re: Lot 2/RP866235 – Free Street, Newmarket

CHEMICAL HAZARDS AND EMERGENCY MANAGEMENT UNIT
A Division of the Bureau of Emergency Services

RE: Free Street, Newmarket

PAK K 12

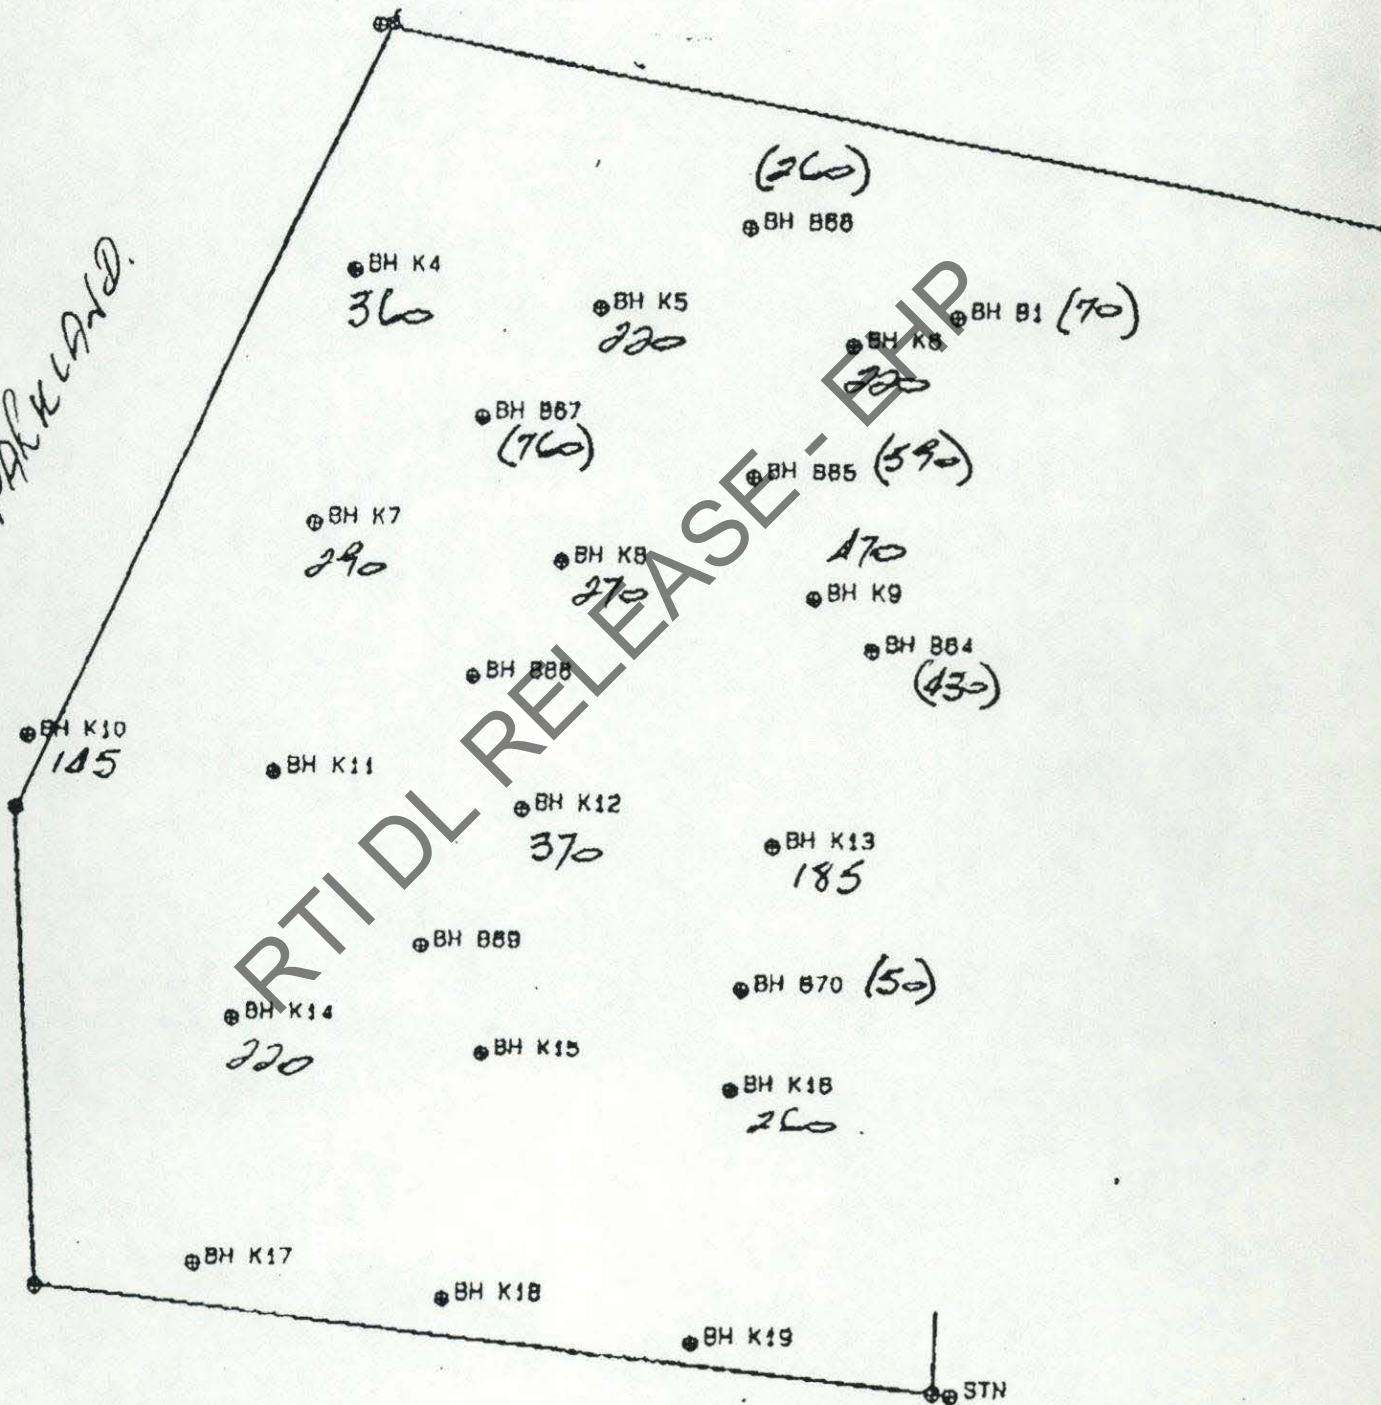
PRIOR TO SUBMISSION OF A
FORMAL REPORT WOULD YOU ADVISE
THAT THESE LEVELS ARE ACCEPTABLE
; IN THIS CASE; GIVEN THE DEPTH OF
FILL YET TO GO OVER THE TOP OF
THIS AREA

STEP 1 - CREATE LAYERED STOCKPILE

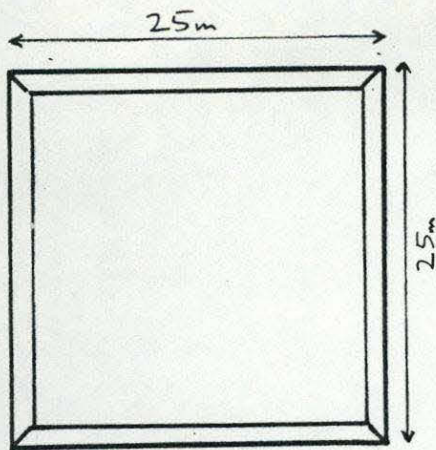
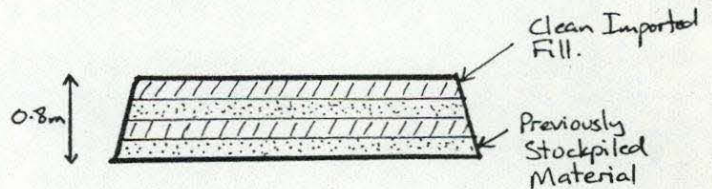
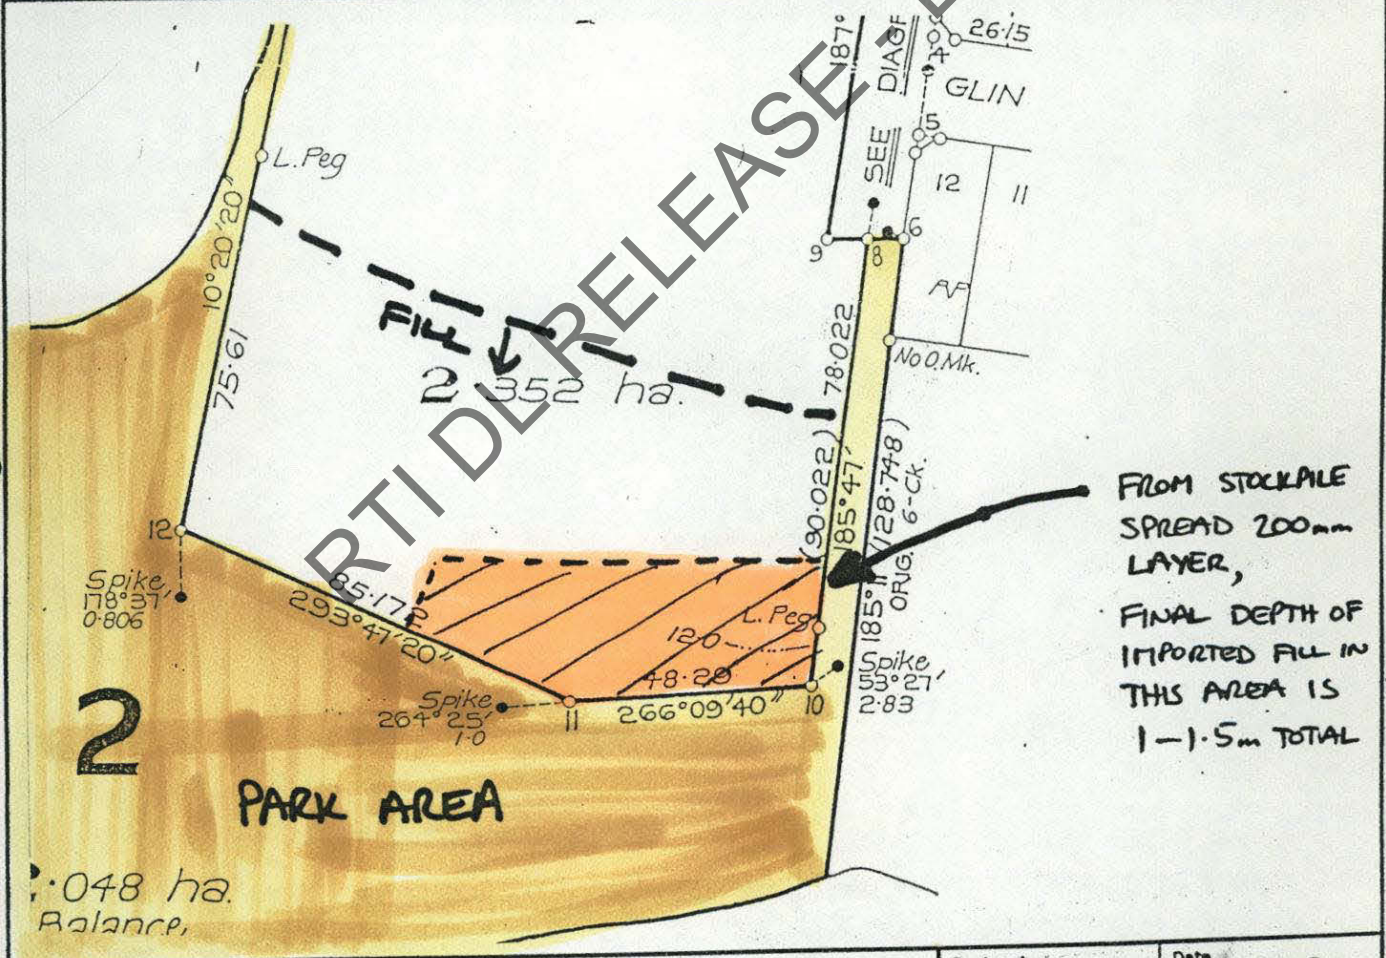
Step 1 - the stockpile of material to be treated consists of approximately 140m³. A 200mm deep layer is to be spread over a 25m square area, and then overlain with a 200mm layer of clean imported select fill. The process is to be repeated, which will give an 800mm pile of thinly layered material.

Step 2 - the material can then be blended by machinery working the full depth of the pile. This will ensure that the layers are mixed fully as each bucket load is taken.

Step 3 - the blended material is to be placed in the deepest area of the site which requires filling and spread in a 200mm deep layer. We propose the area marked on the attached plan, which will mean the layer is to be covered by a further 1-1.5m of clean imported filling.

We would appreciate your comments and approval on this procedure as soon as possible, as our client is extremely anxious to resolve the matter.

AFTER CONSIDERATION BY THE UNIT TOXICOLIGIST, IT IS AGREED THAT FURTHER
BLENDING OF SOIL ON THE SOUTHERN END OF STAGE 2 & 3 IS NOT NECESSARY.
COULD YOU PLEASE ADVISE THE DEPTH OF FILL WHICH IS TO BE ADDED TO THIS
SECTION OF THE SITE.
